Hampshire County Council

PROOF OF EVIDENCE OF JONATHAN MUNDY IN RESPECT OF HIGHWAYS AND TRANSPORTATION

Outline Planning Permission For The Demolition Of Existing Buildings And Development Of Up To 75 Dwellings, Open Space, Vehicular Access Point From Newgate Lane And Associated And Ancillary Infrastructure, With All Matters Except Access To Be Reserved. Land At Newgate Lane (North) Fareham.

APPEAL REFERENCE APP/A1720/W/20/3252180

Staging Diagram

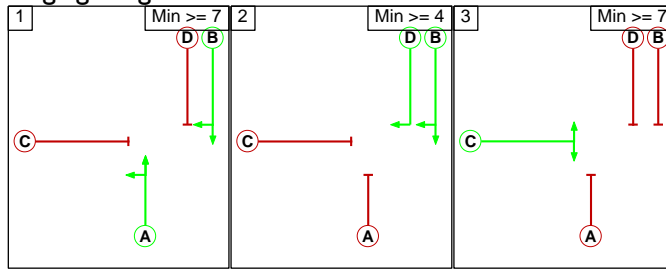
4.4 The proposed staging would allow drivers to turn right from Newgate Lane East into Old Newgate Lane during stage 1. This would result in drivers turning right across two lanes of oncoming traffic. Poor driver judgement in finding a safe gap across two lanes of traffic travelling ahead within a traffic signal junction is considered to present an unacceptable safety hazard.

4.6 Under the Appellant's proposed staging the right turn movement from Newgate Lane north into Old Newgate Lane could occur at three points during the cycle of the signals

- during stage 1 with drivers turning right between gaps in the oncoming traffic flow
- during the interstage period between stages 1 and 2
- during stage 2 when they would have right of way with the right turn indicative arrow

4.7 Drivers arriving during stage 1 would have to make judgement to find a safe and acceptable gap in the oncoming traffic flow in which to complete their turn. The oncoming traffic may pass through the junction in two lanes. The presence of a vehicle approaching in the lane nearest to the waiting driver may obstruct the visibility to a vehicle in the furthest lane. When making a decision on when it is safe to turn the driver may have limited or no awareness of a vehicle in the furthest lane. The driver would make their decision on when to turn based on the gaps in the traffic flow in the traffic lane they can see. The safety risk occurs as the right turning driver who has started to make their turn and is partially across the oncoming traffic lanes comes into conflict with an unsighted vehicle travelling through the junction in the furthest lane.

4.8 The majority of drivers in the furthest lane would be travelling straight ahead through the junction. This means that they would not be slowing down or be expecting to slow as they would have a green signal and be so close to the junction. The speed differential would contribute to the severity of a collision. The most expected form of collision would be a side impact to the right turning vehicle and driver.

4.9 Stage 1 would run for the majority of the signal cycle and the majority of drivers wishing to turn right would be faced with having to judge a safe gap to turn across the 2 lanes of oncoming traffic.

4.10 The Appellant's proposal would introduce an unacceptable yet avoidable safety risk to the junction.

4.5 To eliminate this safety hazard would require the full signalisation of the right turn traffic movement from Newgate Lane East into Old Newgate Lane. Under this arrangement right turning drivers would be prevented from turning during gaps in the oncoming traffic flow. Right turning drivers would be held at a red signal and could only turn when the oncoming traffic was stopped at a red signal. This is the only acceptable method of allowing the right turning movement across 2 lanes of ahead traffic. The staging arrangement be
